Leeds' plan for flood easing from Apperley Bridge to Calverley

Comments by Onno Bokhove

Regarding Leeds' flood-mitigation plan for Apperley Bridge, Bradford

Figure 1: Graph relating to point a) above. Natural green berm/dike instead of industrial steel-sheet pile wall. Similar to a drawing in [1], along Apperley Road. Black arrows, larger text and cross-section of new berm against existing wall (upper-left) added by OB.

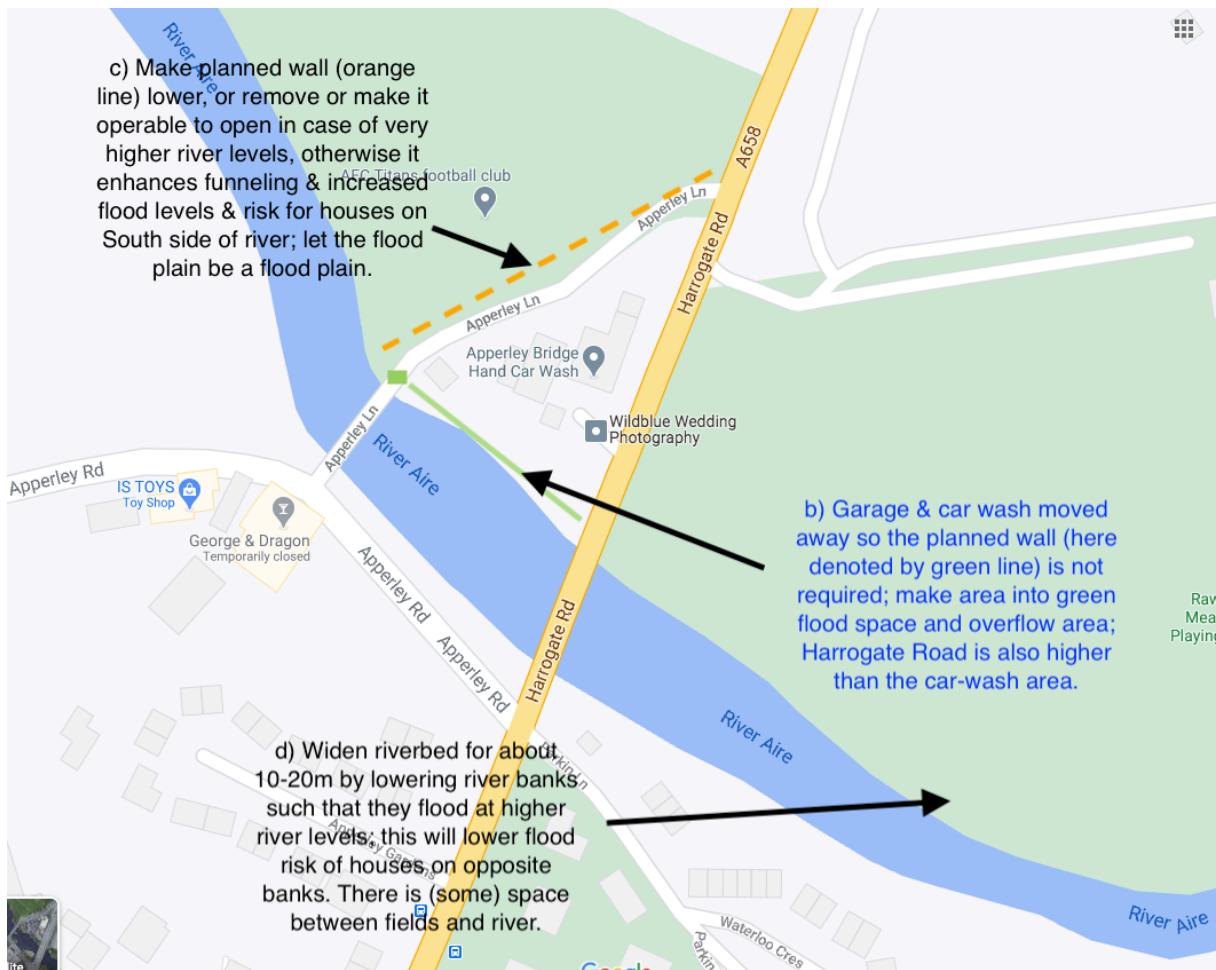
- a) ***An alternative, possibly cheaper and certainly greener, solution to the steel-sheet pile wall*** on the South side of the river along the minor road to Apperley Bridge (see drawings in [1] and Fig. 1) is a berm formed by clay/soil with grass on top, e.g., clay/soil from the in-situ flood plain, which would result in a zero-or-negative volume change, concomitantly creating more-or-zero change in floodplain-storage capacity. This would be an example of a green *Nature Based Solution* (NBS), a berm or dike, which can fit seamlessly and naturally to the existing stone wall (with repairs of that wall where necessary) along Apperley Road. See also Fig.1.

Question 1: How does the steel-sheet pile wall look (there is no image); what are its costs relative to green dikes/berms, in terms of construction and maintenance?

Figure 2: Remarks with locations indicated relating to points b), c) and d) above. Similar to a subsection of a drawing in [1], along the River Aire in Aupperley Bridge. Fat arrows and black/blue text added by OB. (Grid reference: SE 19475 37978)

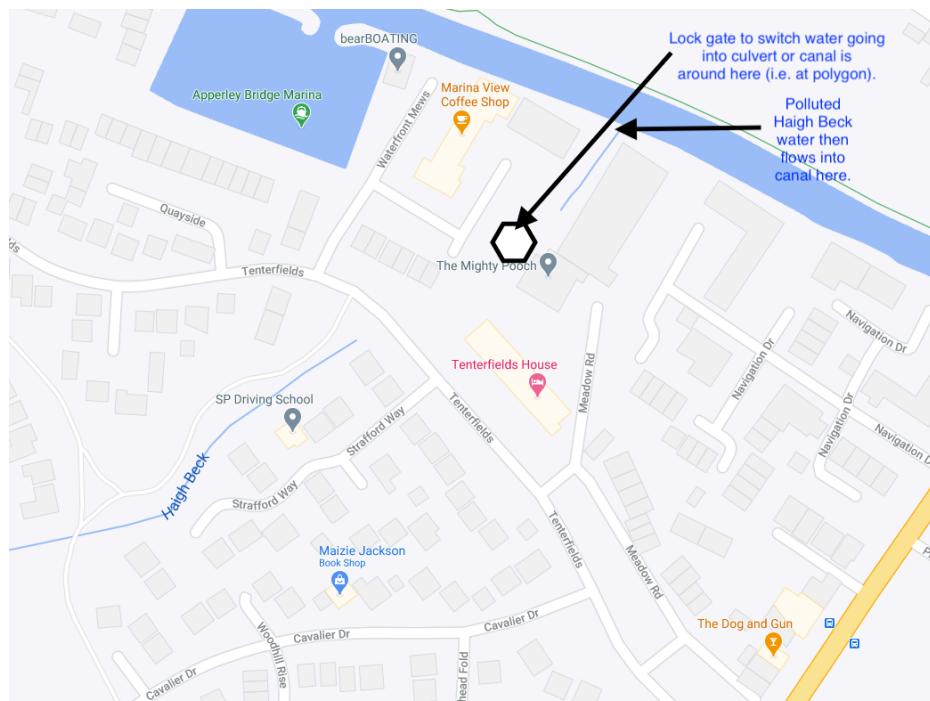
- b) There is a steel-sheet pile wall planned along the North side of and directly along the river to protect the garage (see drawings on [1] and Fig. 2). ***The garage and car wash, however, have recently moved.*** Both garage and car wash are/were polluting the river. The area can be, with the soil cleaned, lowered and made into green space; the river bank there can also be widened and lowered in places, thus giving more room to the river and better preventing floods on the built-up South side because the water can go somewhere (i.e. it can flow onto the floodplain as intended by nature). Hence there seems to be no need for this steel-sheet

- pile wall on the North side along the river between the two bridges. See also Fig. 2. The steel-sheet pile wall connects the two bridges but note that the bigger bridge has open sides and that the garage land and road off the small bridge are lower lying; the bigger road lies higher; hence, there is no need for this wall in order to protect the bigger road. See also the connection with point c) below as well as Fig. 4.

- c) A closed steel-sheet pile wall on the North side of the river along the minor road coming off the old Apperley Bridge will lead to enhanced funneling of the river and, hence, increased river-levels which, recalling point (i) above, puts the houses on the South side at increased risk of flooding. Furthermore, under climate change such flood risk is expected to increase. Instead, these walls could be lowered, not strengthened/raised, or possibly several operable gates could be included that can be opened at very high river levels to lessen the pressure on the South bank flood-defense wall. In conjunction with b) above, flood waters can then flow over this road (in a case without wall or with a lowered wall) and the flood waters can be led away via the new lowered space between the two bridges. Cf. Akers and Bokhove 2008 [4]. See also Fig. 2.
This entire wall can be a green berm as in point a) above, instead of a steel-sheet pile wall, which (berm) is more green, with lock gates to be opened when river levels rise too high such that the flood plain is flooded rather than the collection of houses on the South shore.

- d) Downstream of the main bridge on the North side, the football pitches are far enough from the river that it is possible to widen the flood channel somewhat, by lowering the banks ~1m-to-2m over a strip, adjacent to the river and of width ~10m, which will be dry during normal river flow but covered with river water and creating more through-flow at lower river levels when the river level rises, see Fig. 2. This is an example of modern giving-room-to-the-river (GRR) flood-mitigation practice and Nature Based Solutions (NBS) [2].

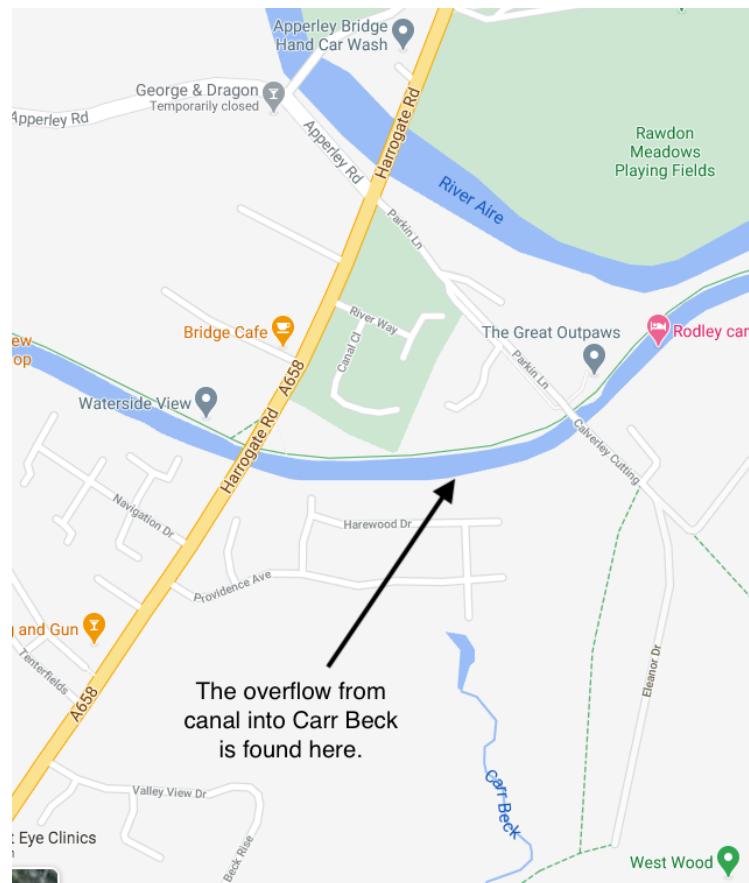
- f) The water from Haigh Beck, the beck flowing through Apperley Bridge just North of the canal, once cleaned (of the substantial accumulation of pollution by pieces of industrial cloth, etc.), could preferably flow into the canal and then into Carr Beck via the overflow, further along the canal, thus creating an extra buffer. By doing this, the beck water then avoids filling culverts under housing, and a more green and healthy beck has also been created.

On 06-02, OB led the EA officer, a flood victim and Yorkshire Water/West people on site to the lock gate just off Tenterfields, where the beck water on that day was divided for circa 10% into the canal and for circa 90% into the culvert towards the houses next to the river between the two bridges. Nobody had the key to the lock to control the flow or knew who had the authority to control these diversions of the beck flow. Critical issue is whether the (perhaps heavily) polluted beck waters should, in case of a flooding emergency, flood either the (cellars and gardens of) houses or the canal. The canal has an overflow into Carr Beck and the River Aire. In the 21st century the gate could be automated, with waterlevel/flow

and quality sampling, and operated with AI, including a manual override. Such remotely run water-level controls on canals are found everywhere nowadays, e.g. in The Netherlands, so there must be affordable set-ups available. See also Fig. 3.
